Groundwater Application Review Summary Form

Application # G- 18831	, ,
GW Reviewer Phil Marcy Date R	eview Completed: 6/18/2019
Summany of CIM Availability and Injumy Pavious	
Summary of GW Availability and Injury Review:	
[] Groundwater for the proposed use is either over appropriamounts requested without injury to prior water rights, OR was capacity of the groundwater resource per Section B of the attention	vill not likely be available within the
Summary of Potential for Substantial Interference Review:	
[] There is the potential for substantial interference per Sect	ion C of the attached review form.
Summary of Well Construction Assessment:	
[] The well does not appear to meet current well construction review form. Route through Well Construction and Complian M 6118/19

Review of Water Right Application G-18831

TO: Water Rights Section Date <u>06/18/2019</u> FROM: Groundwater Section Phillip I. Marcy														
						Reviev	ver's Nam	ne						
SUBJE	CT:	Applic	cation G- 1	8831		Sup	ersedes	rev	riew of		D	ate of Revi	ew(s)	
PURLI	C INTE	REST	PRESUN	APTION; O	CROUND	WATER								
OAR 69 welfare, to deter	90-310-13 safety and mine whet	0 (1) <i>The health</i> ther the	he Depart

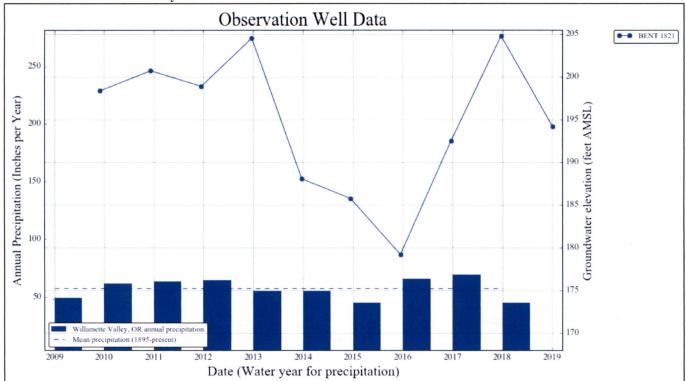
BENT 1821 is located 9,000' ENE of the proposed POA well, is of similar depth, and displays reasonably stable water levels that appear to be correlated with annual climatic variability.
